DOCKETED	
Docket Number:	23-AFC-03
Project Title:	Black Rock Geothermal Project (BRGP)
TN #:	258933
Document Title:	Exhibit J UAW comments on Black Rock Geothermal Project PSA
Description:	N/A
Filer:	Matthew Maclear
Organization:	Aqua Terra Aeris Law Group
Submitter Role:	Intervenor Representative
Submission Date:	9/4/2024 1:48:16 PM
Docketed Date:	9/4/2024

UAW Comments on Black Rock Geothermal Project PSA

**Comments on the Deficient Air Quality Analysis in the California Energy Commission
Preliminary Staff Assessment for the Black Rock Geothermal Project, July 2024
CEC-700-2024-004-PSA, DOCKET NUMBER 23-AFC-03**

⁶ PSA Figure 1-1.

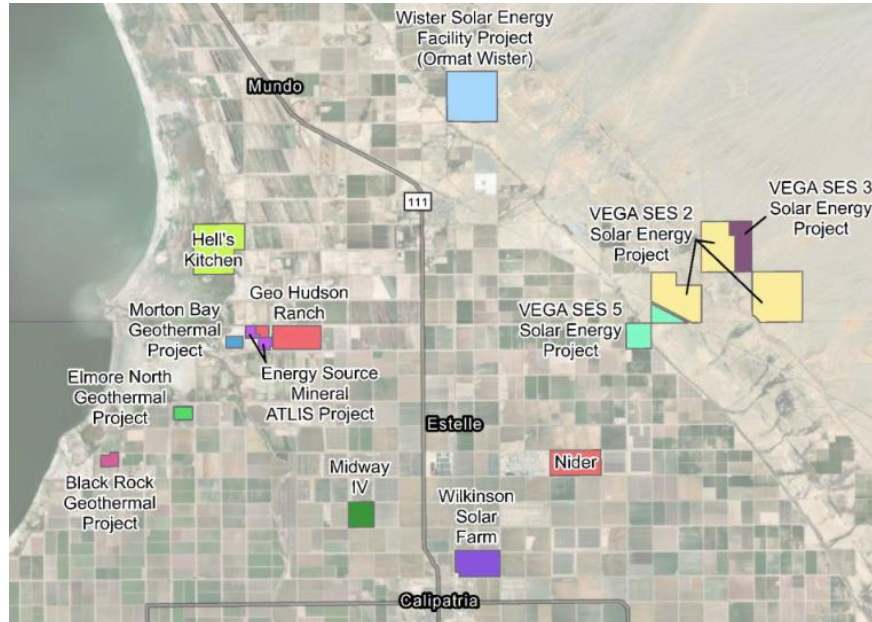
The Figure⁶ below shows the geographical area of the BRGP as well as other nearby projects. In particular, the Elmore North Geothermal Project and the Morton Bay Geothermal Projects are believed to be “sister” projects under common ownership as the BRGP.⁷

C.1.3 Changes to the Salton Sea. It is clear from the previously shown Figure that the BRGP and its sister projects are located adjacent to the Salton Sea. Due to climate impacts in the Southwest United States, the Salton sea is drying-out and shrinking. As this occurs, the smaller future footprint of the Salton Sea has and will continue to expose substantial new dry playas and these would be sources of increased fugitive dust based on wind entrainment. Substantial additional and massive PM (including PM_{2.5} and PM₁₀ or varying compositions, including toxic metals) will be emitted into the general vicinity of the Sea. It is well known that dry playas exposed due to shrinking bodies of water such as the Salton Sea can be very large sources of emissions. In fact, this has been noted specifically for the Salton Sea itself. Researchers at UC Davis note,¹⁷ in particular that newly exposed playas are “more susceptible to wind erosion” and “particularly emissive in terms of dust.” UC Riverside researchers have confirmed this as well, calling the consequences of this drying lake “an environmental catastrophe.”¹⁸
